From: Catherine Townend <Catherine.Townend@nationalhighways.co.uk>
Sent: 15 June 2026 16:39
To: Darren.Ottewell@broxtowe.gov.uk
Cc: Alan Siviter; Daniel Law
Subject: National Highways response - Planning application re-consultation - 25/00371/OUT Land west of Stapleford Lane (aka Toton West)
Attachments: National Highways updated response - June 2026.pdf; RE: Planning application re-consultation - 25/00371/OUT Land west of Stapleford Lane

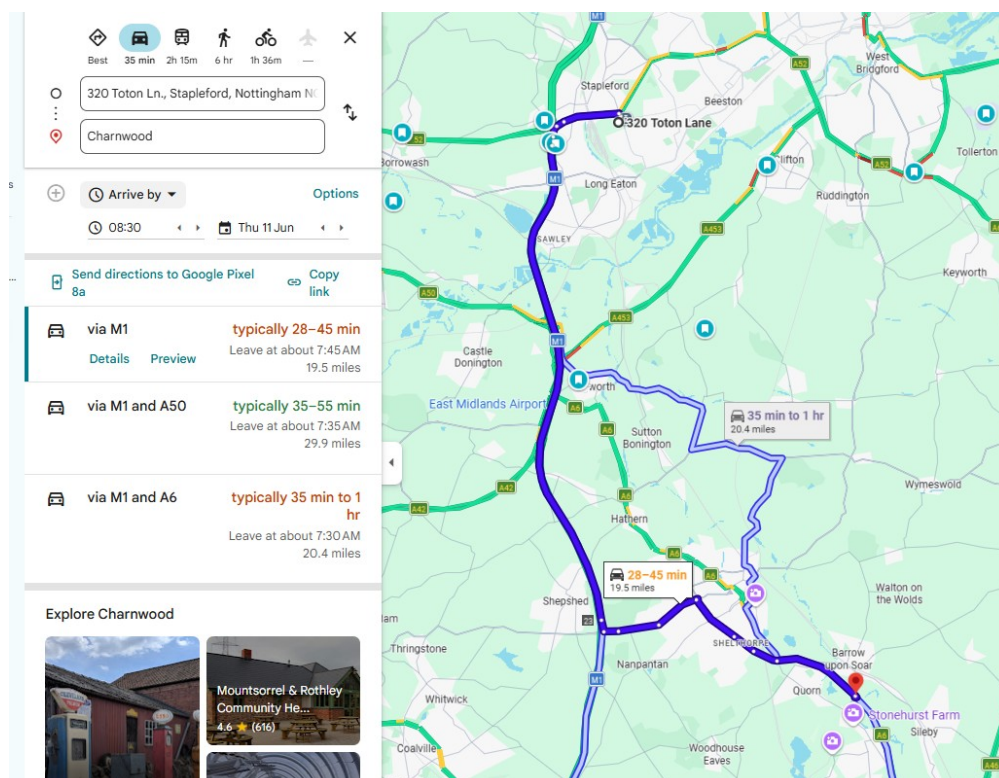
We welcome the details regarding the distribution to and via Zone G. While we are content that the impact of the distribution to and via Zone G for MOSAs in Broxtowe and Nottingham are unlikely to generate significant demand on the SRN by the proposed development, we recommend the applicant re-visit the assigned route for Charnwood, for which we consider the routing shall not be via Zone G, but via the M1, as shown in the Google Map's Journey Planner below:
